DEPARTMENT OF RECREATION, PARKS & CULTURAL ACTIVITIES

Ewald Park Survey Highlights

Report for John Ewald Park Design Feedback

Park Concept Option #1

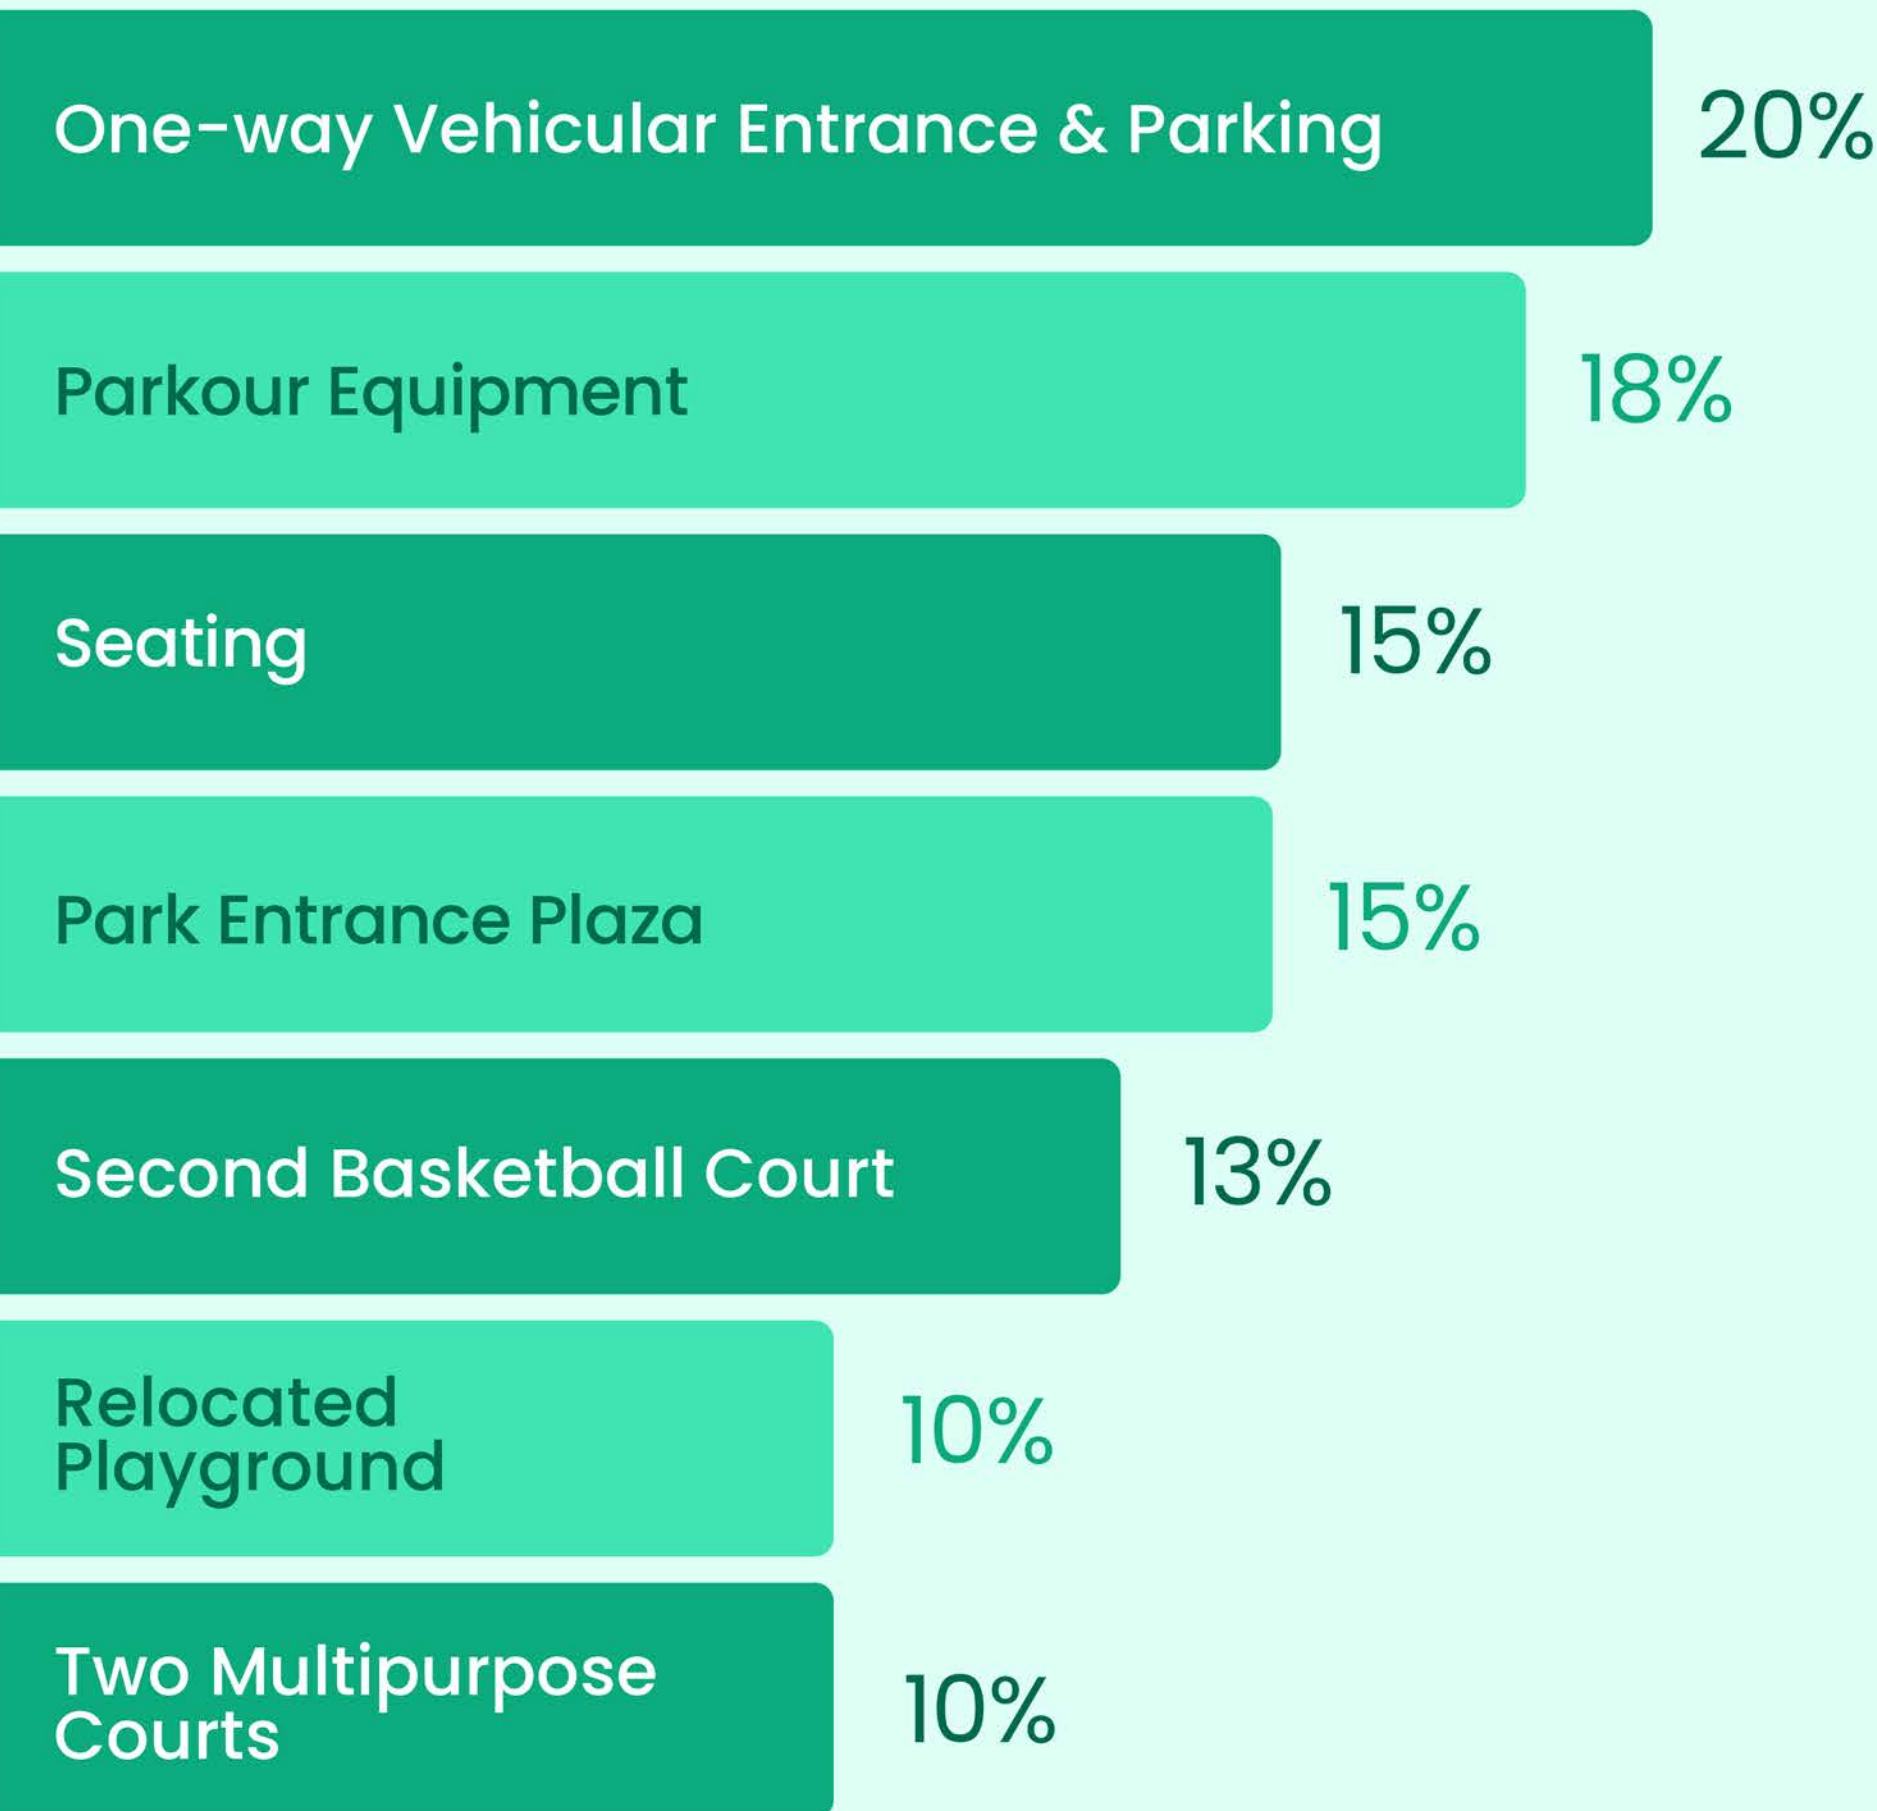
Option 1: Strengths

- More open space
- Playground positioned away from busy roads
- Inclusion of a second basketball court
- Better connectivity through pathways
- Safer parking lot entrance location & traffic flow

Option 1: Concerns

- Some seating areas are too far/not visible from recreational spaces
- Parkour area is not widely desired.
- Need for more shade & tree coverage
- Visibility & site lines

Park Concept Option #2

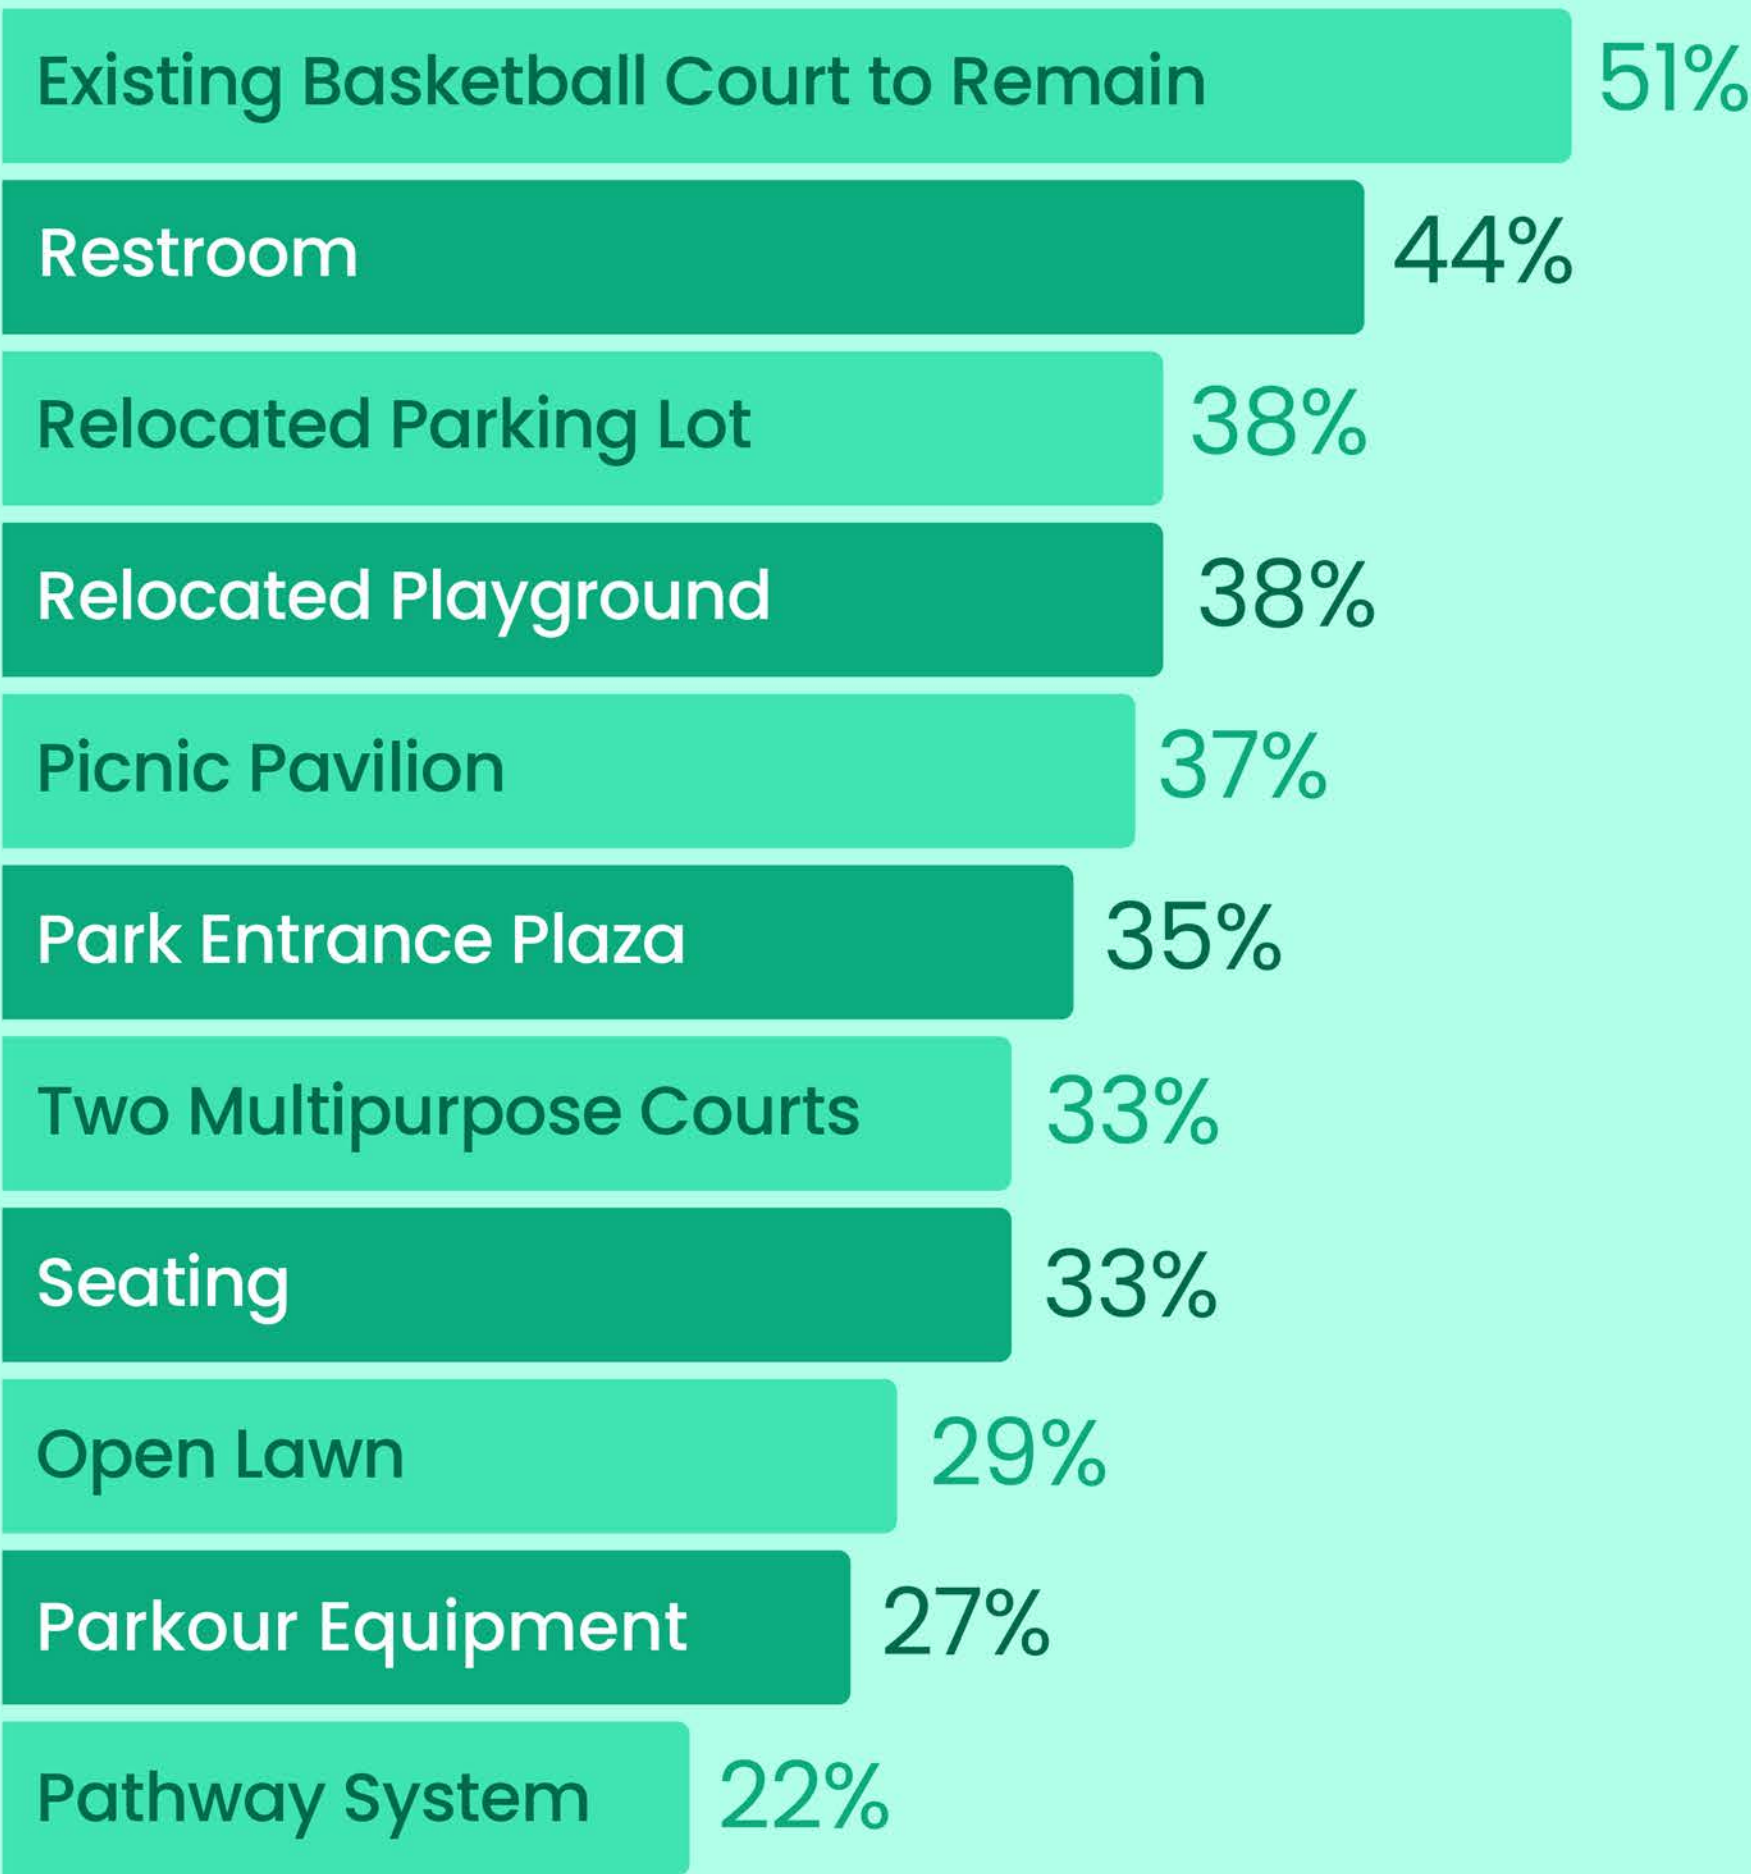
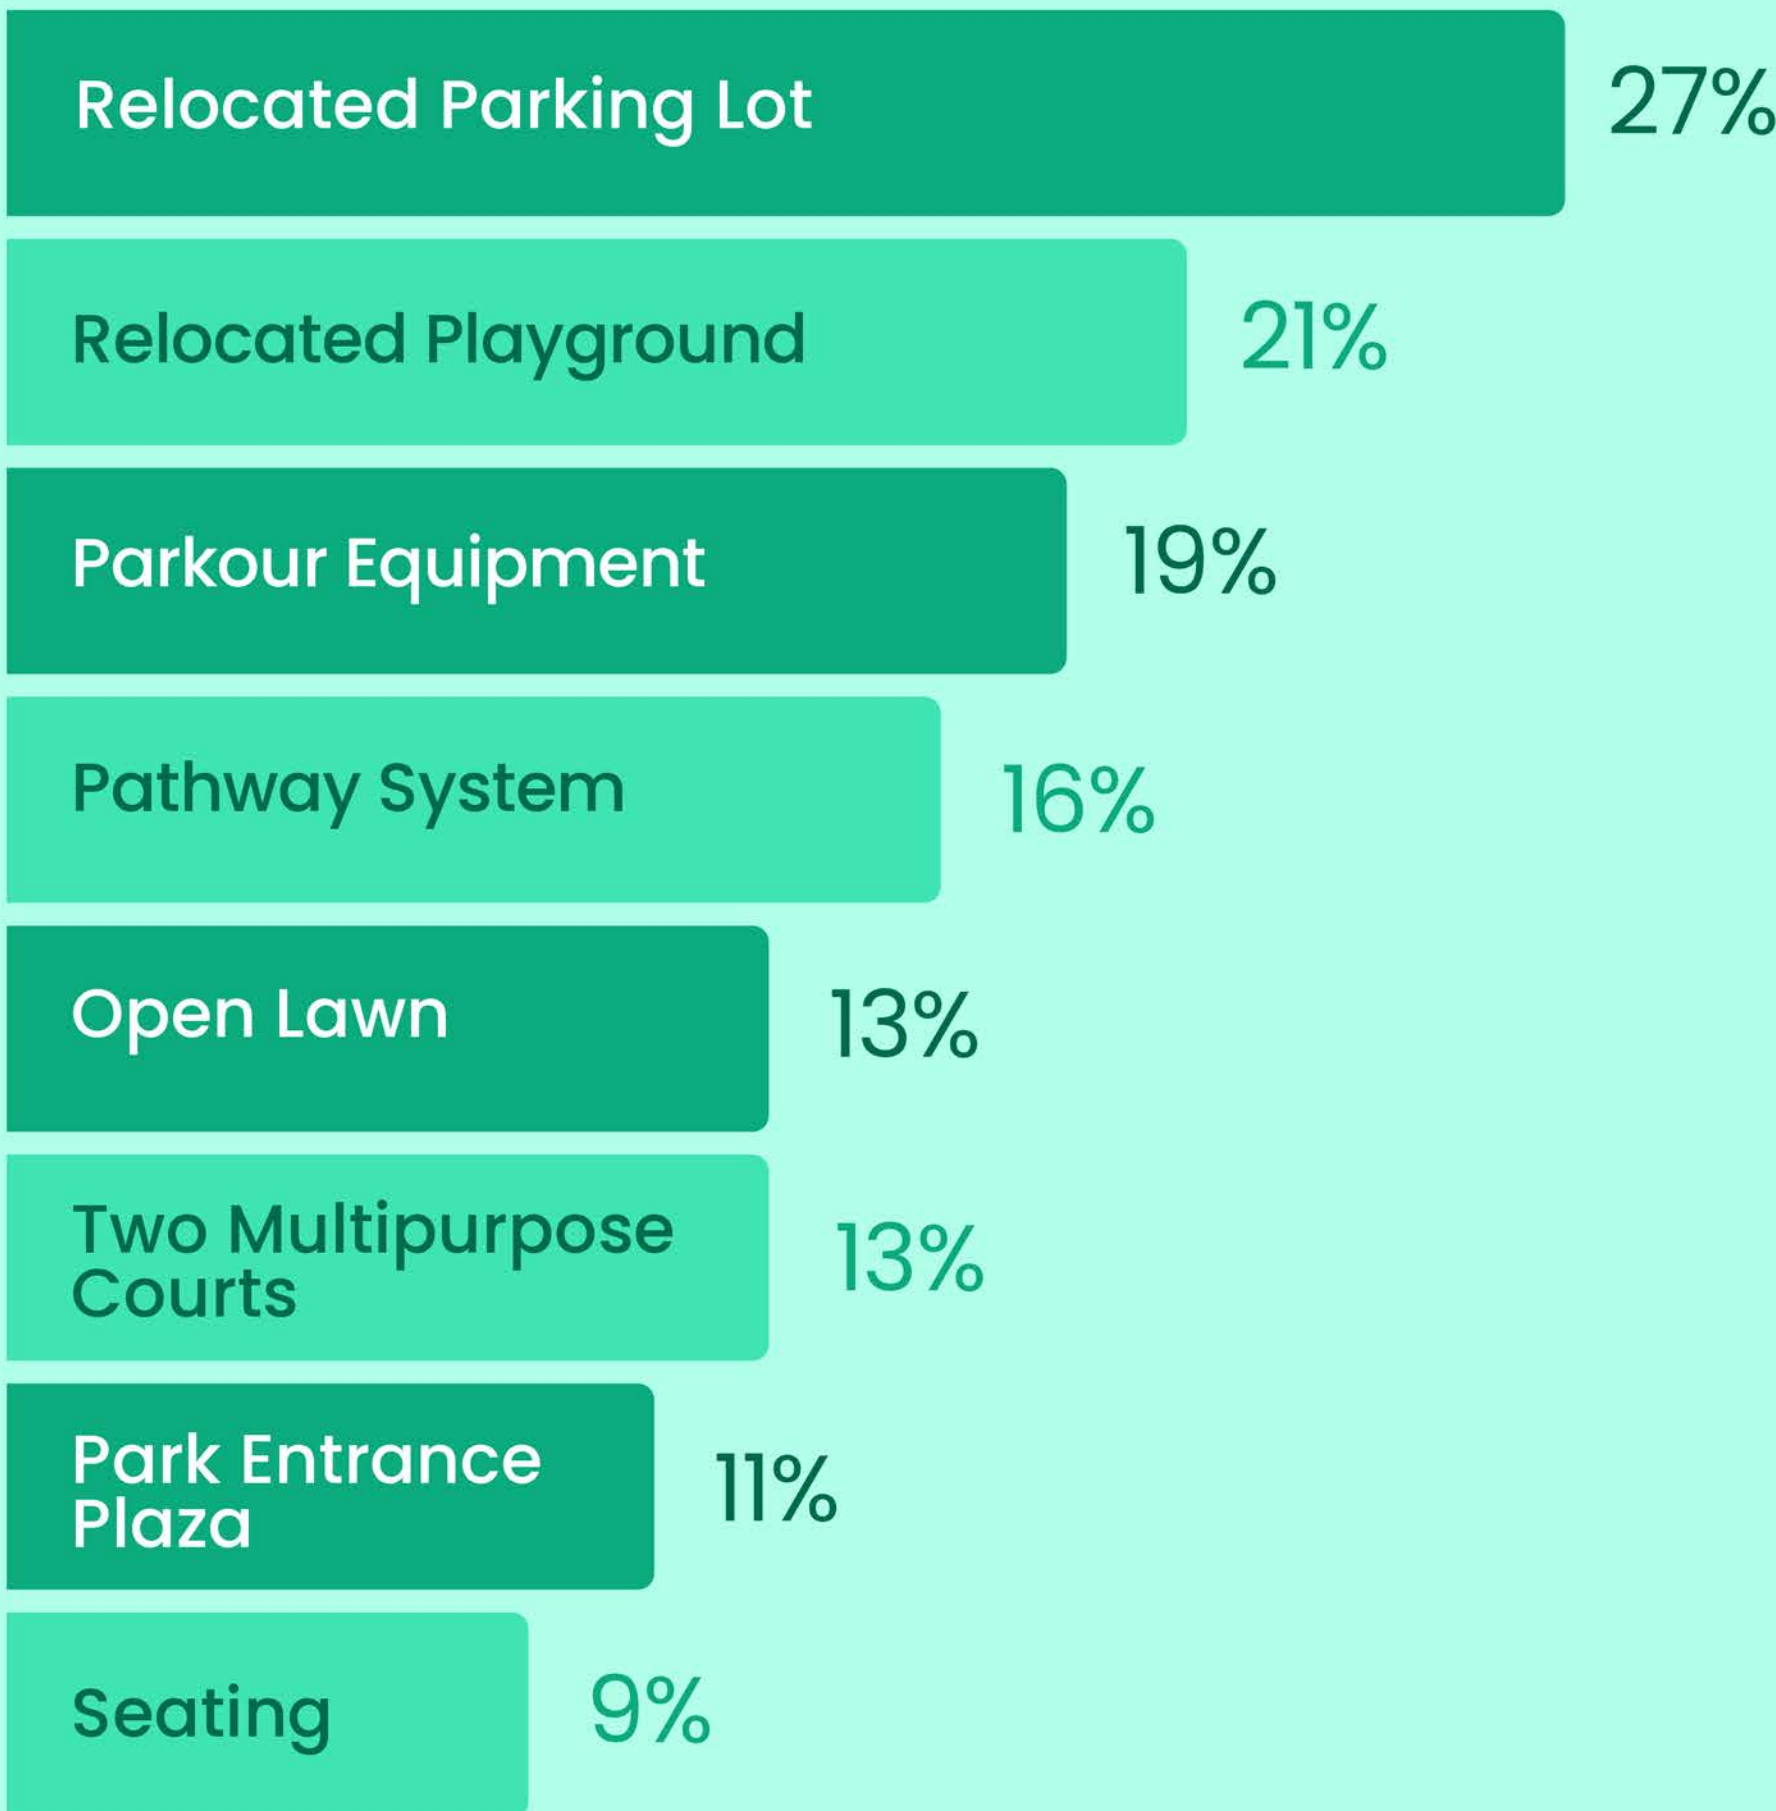
Option 2: Strengths

- Improved visibility of park elements from the street & within the park
- Better organization of amenities for families
- Safer entrance location & improved pathway accessibility
- More centralized layout

Option 2: Concerns

- Playground being too close to the street
- Parking lot relocation may be costly & reduce green space
- Lack of a second basketball court
- Open space appears more limited
- Less pathways throughout the park
